## **CITY OF SOMERVILLE**

# **BUSINESS LICENSE APPLICATION - Grant of Location**

File #: 25-013441 License #: BL25-000065 Address: 1 DAVIS SQ SQUARE Licensee: Jeff Harrington Cambridge Network Solutions DBA Name: Cambridge Network Solutions/Lightpath

# PETITION PLAN AT #1 DAVIS SQUARE (DAY STREET & ELM STREET) IN THE CITY OF SOMERVILLE, MA

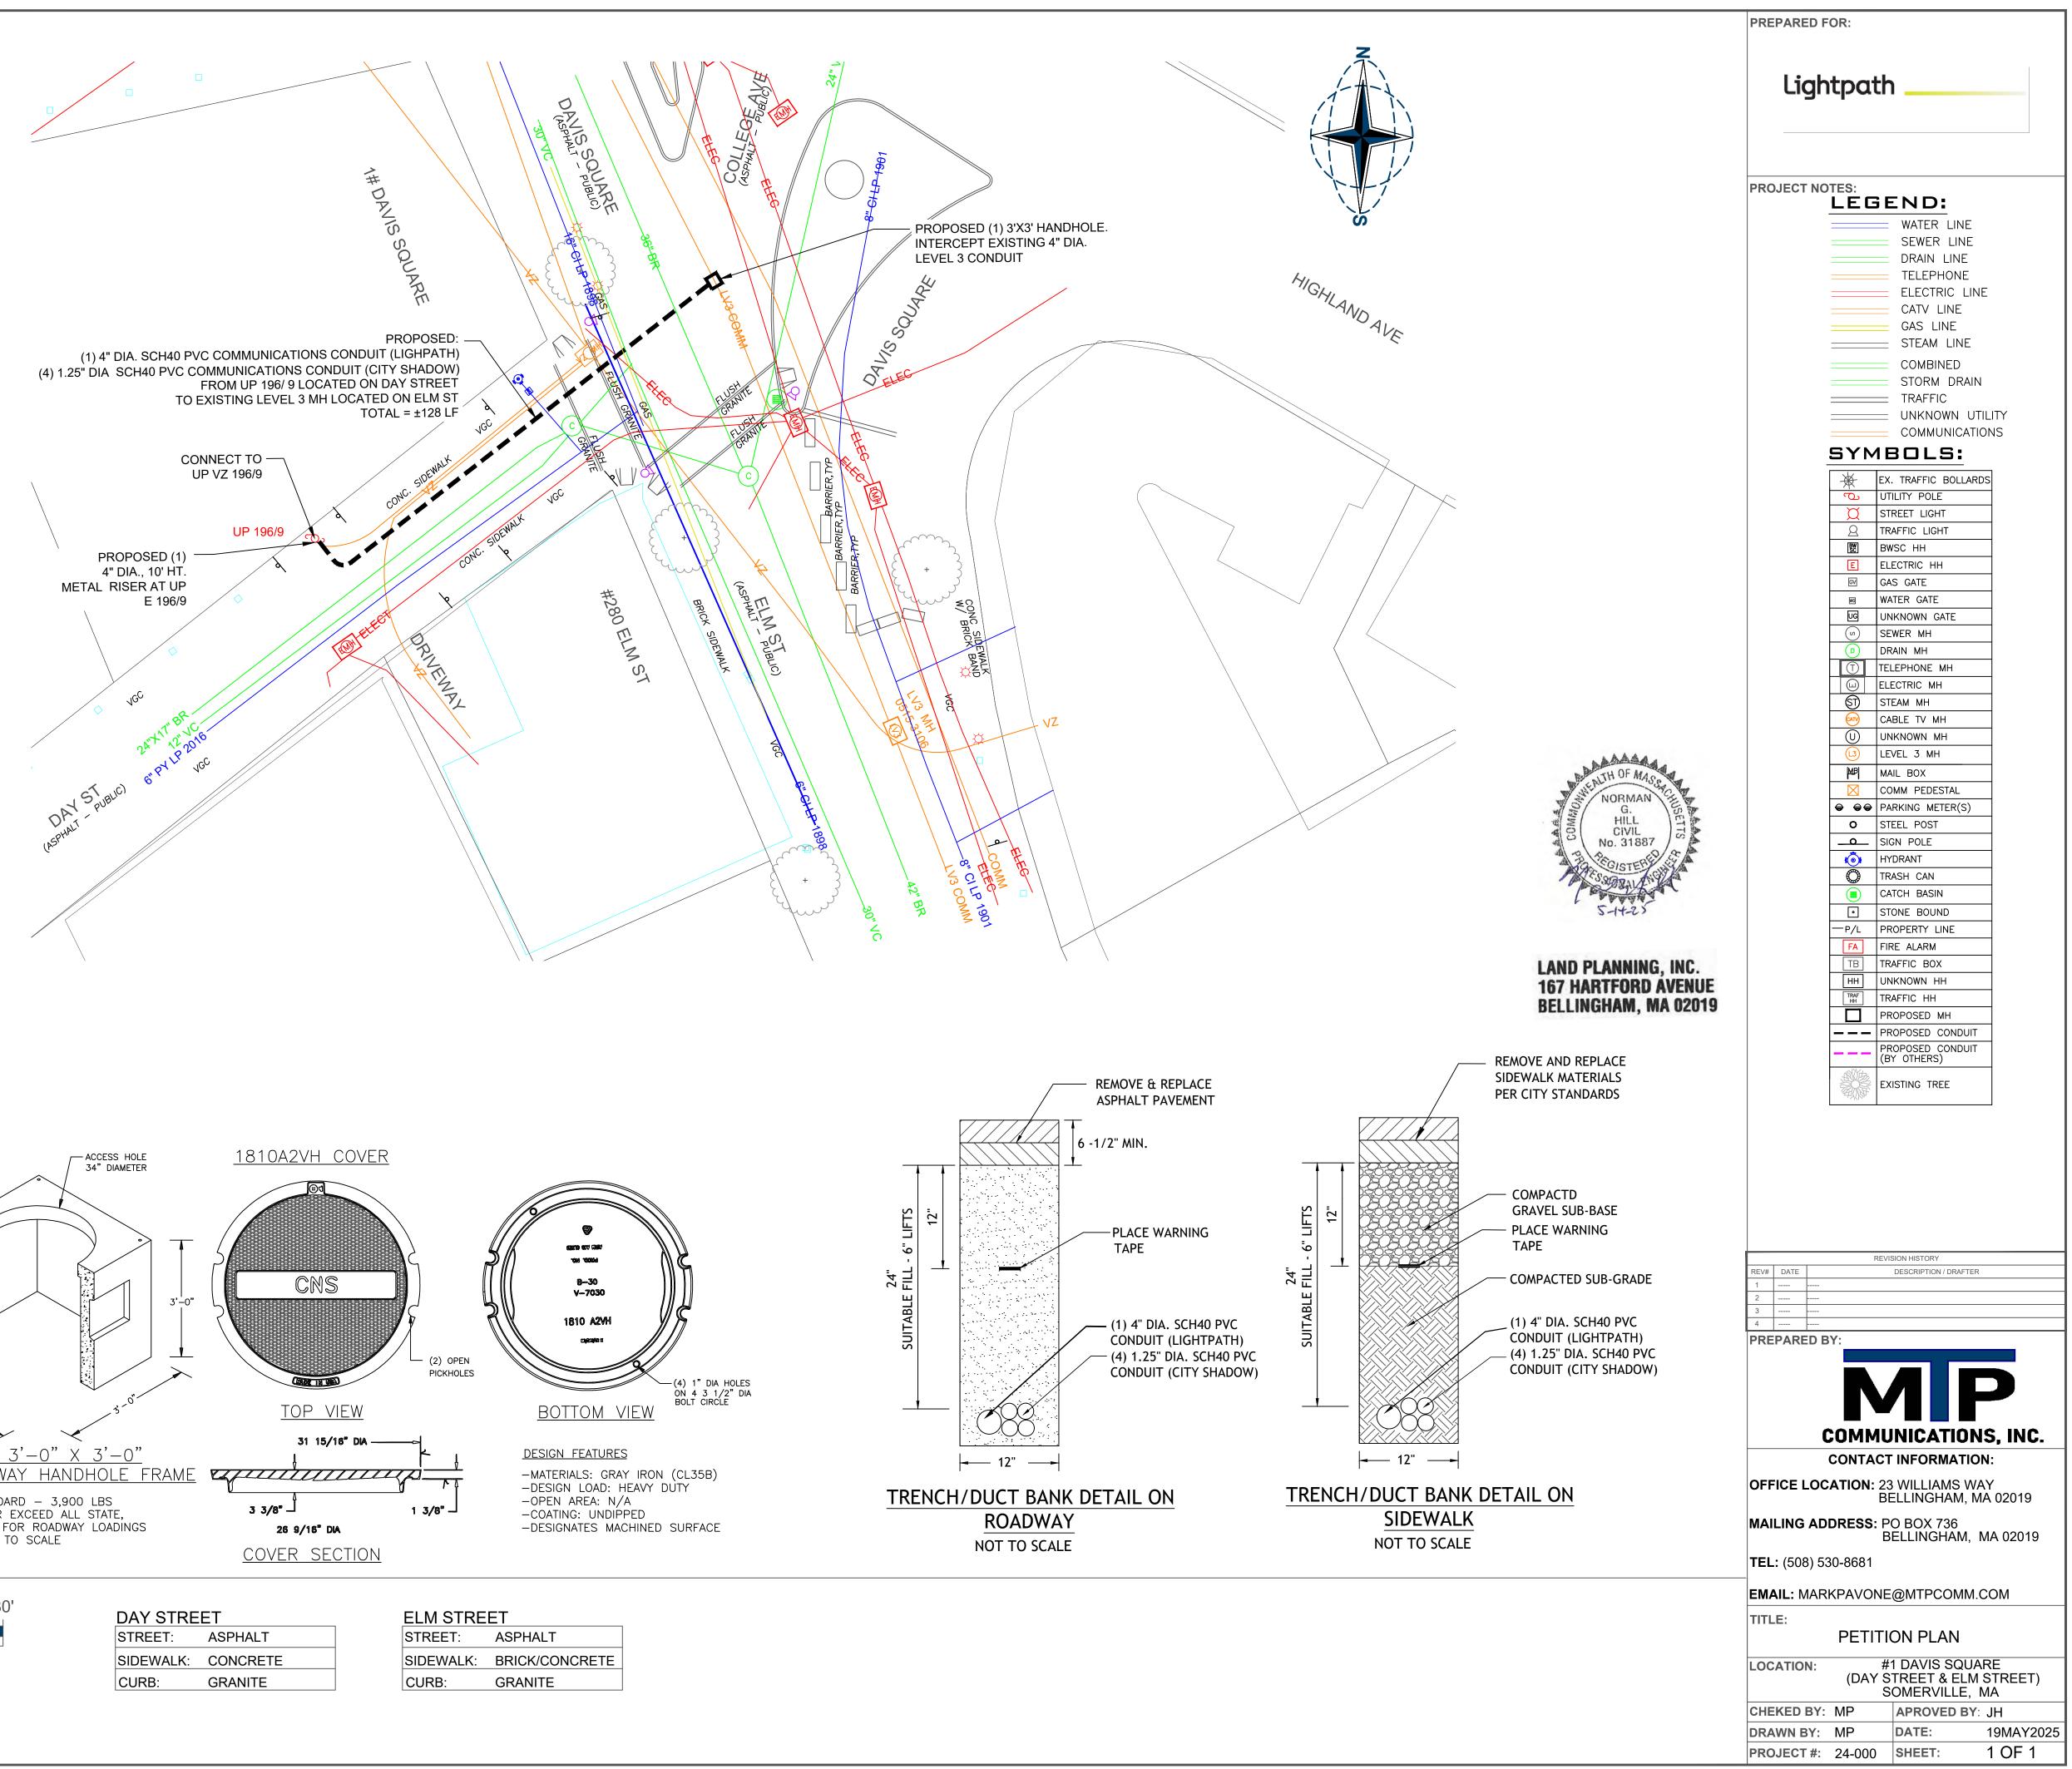
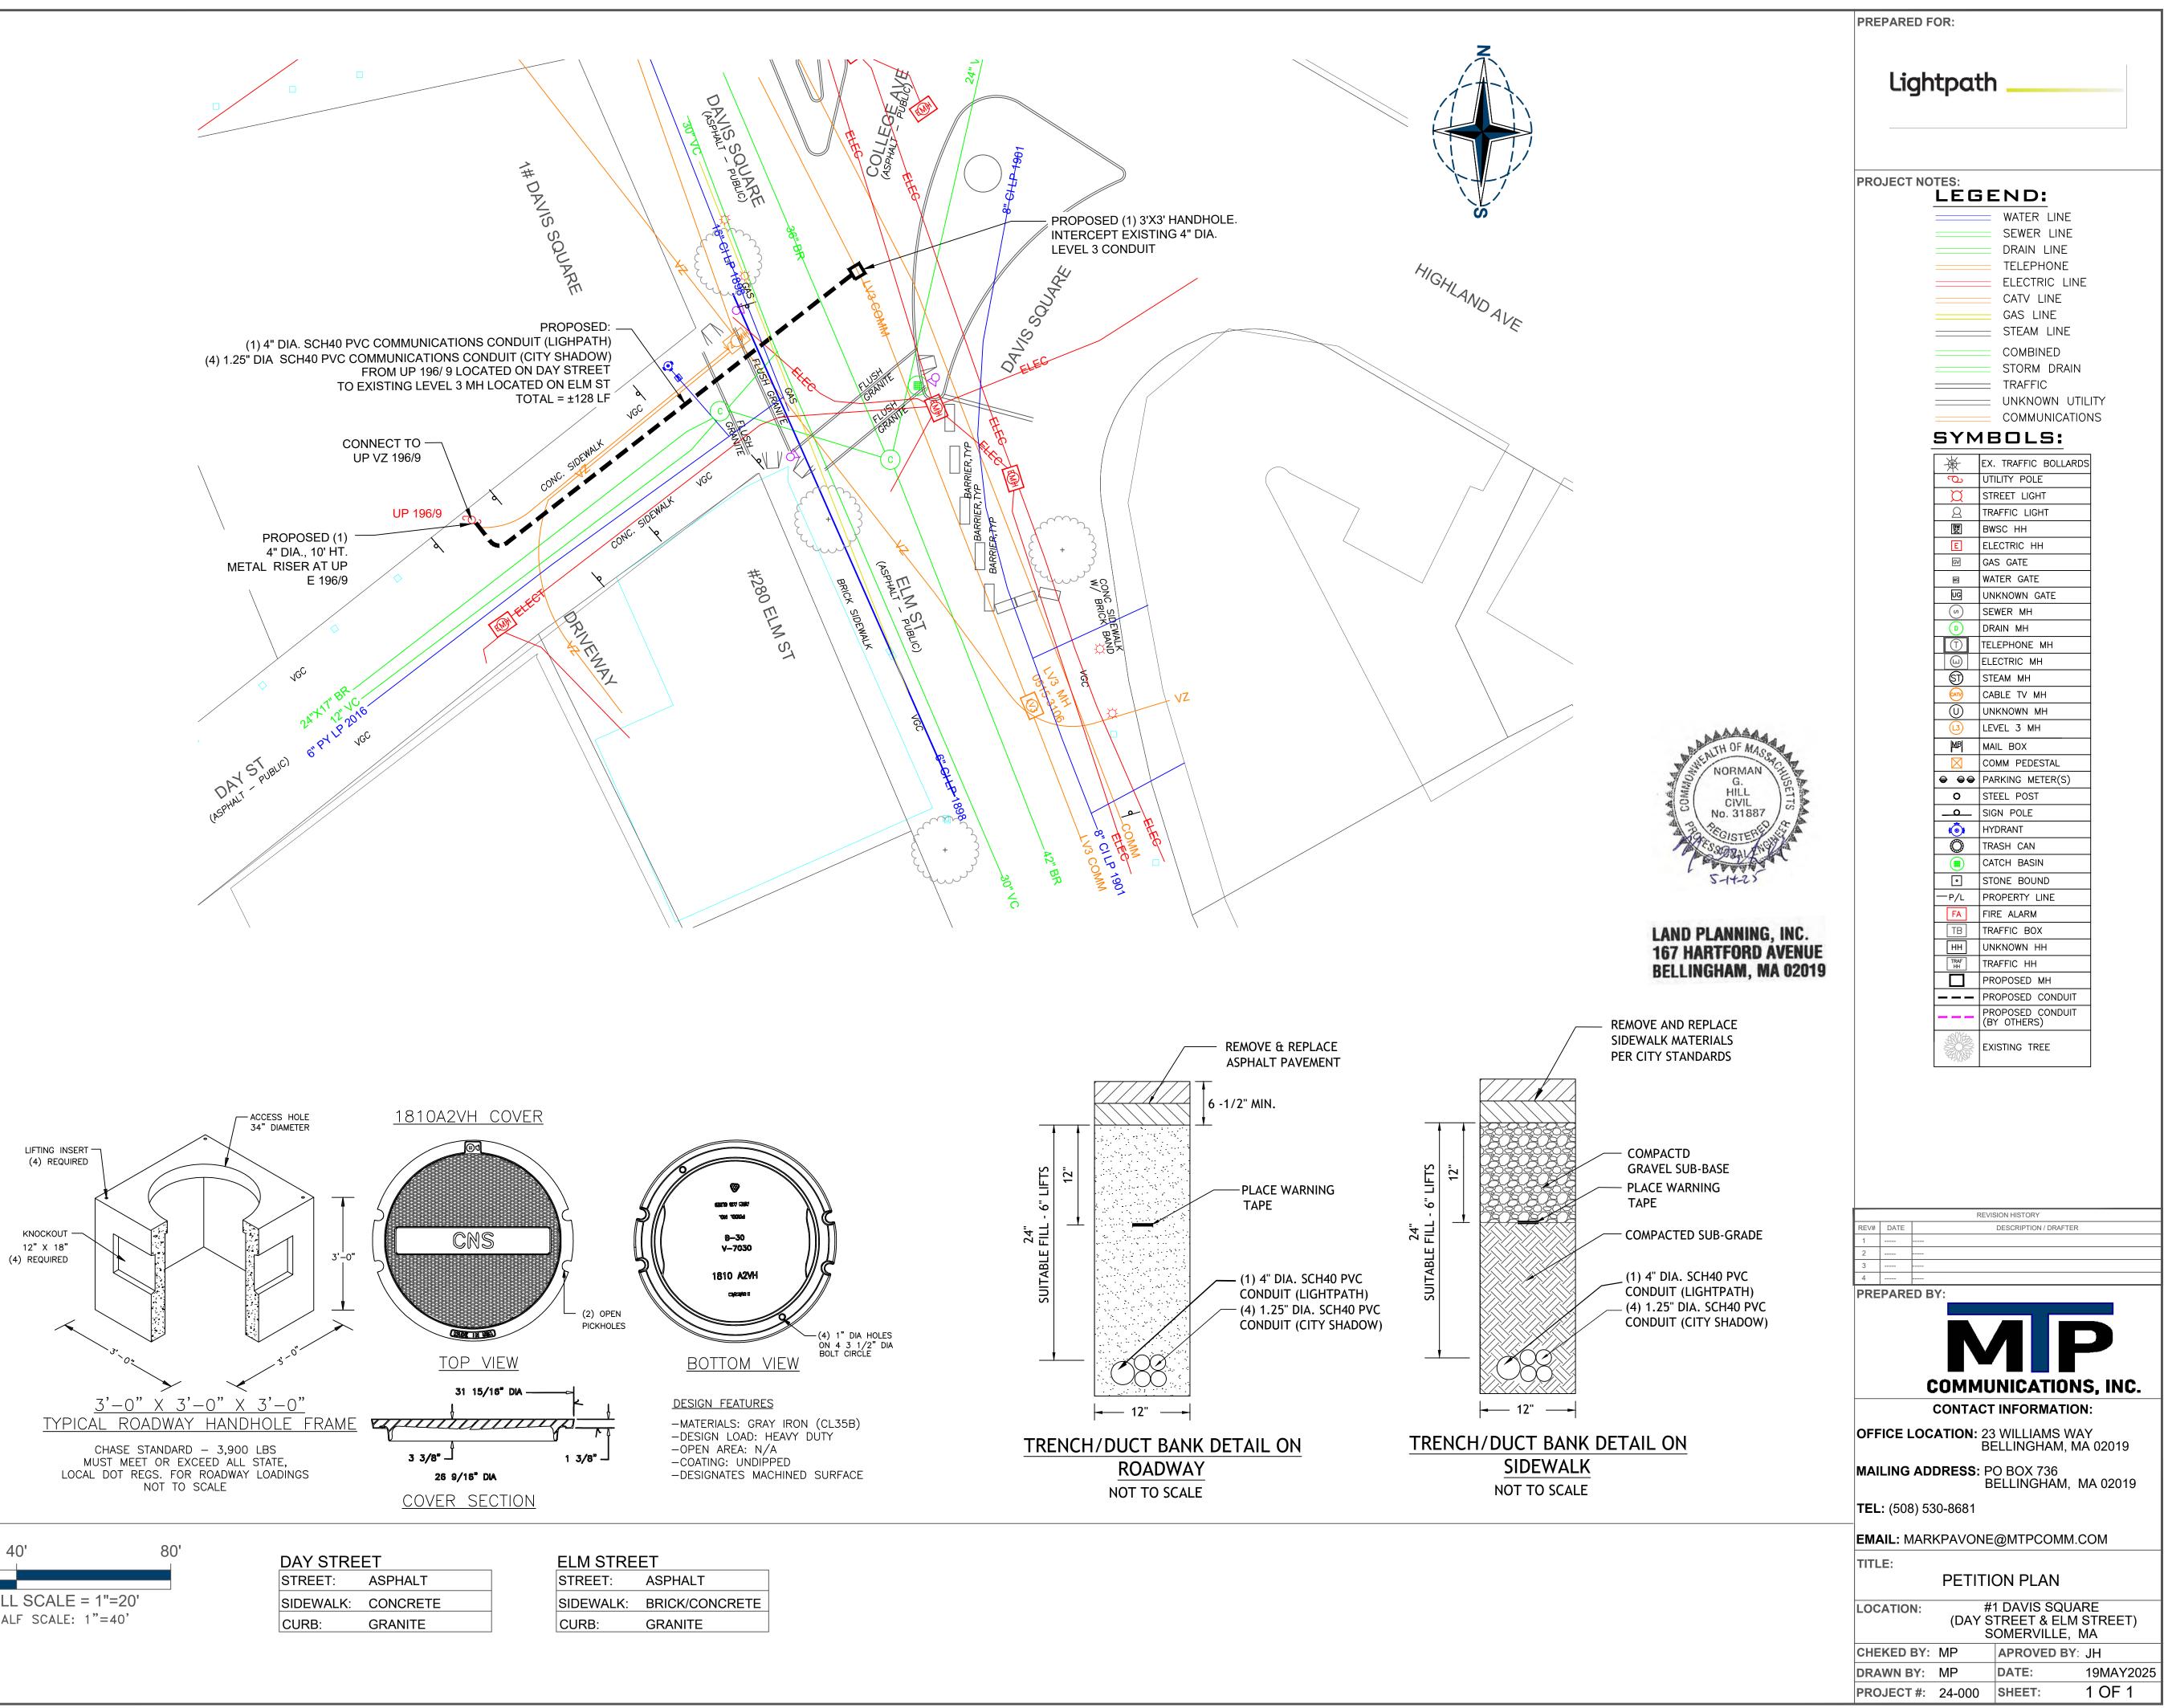
APPROVAL CONDITION: MD20250528: Contractor shall take all necessary precautions to avoid damaging any tree or tree part with equipment.

APPROVAL CONDITION: MD20250528: All nearby street tree(s) shall be protected prior to and during all construction activities using TREE BOX or TREE WRAPS. . TREE BOX shall be constructed from 2 in. x 4 in. lumber creating a box around the border of the tree pit with 2 in. x 4 in. lumber standing straight up at the corners and wrapped with orange snow fence. . TREE WRAPS (TREE TRUNK WRAPPING PROTECTION LUMBER) shall consist of 2 in. x 4 in. and 8 ft. height lumber wired together in close spacing with zip ties or 16 gauge galvanized steel wire to form a protective enclosure around tree trunks. Use burlap to separate the wood from the bark if necessary to prevent wood from scraping or bruising bark. Do not use staples or puncture the trunk in any way.

APPROVAL CONDITION: MD20250528: Any tree roots less than two (2) inches in diameter that cannot be avoided during construction shall be carefully and cleanly cut with a clean pair of pruning shears or loppers. Roots are to be cut back flush with the edge of the trench. If any tree roots greater than two (2) inches in diameter are encountered, stop work immediately and contact the City Urban Forester. Any and all pruning of roots greater than 2 inches in diameter must be completed under the supervision of the City Urban Forester.

APPROVAL CONDITION 06/03/25-Mf: Concrete sidewalk to be restored in-kind after conduit installation. APPROVAL CONDITION 06/03/25-Mf: Any work requiring the use of the street and/or sidewalk will require a Street/Sidewalk Occupancy Permit from the Engineering Department. Apply via Citizen Serve before conduit installation.

APPROVAL CONDITION 06/03/25-Mf: The cross walked located at the intersection of Day st and Elm St have granite stones that can not be cut, crosswalks must be reset immediately following installation. **Eric Weisman, Approved**
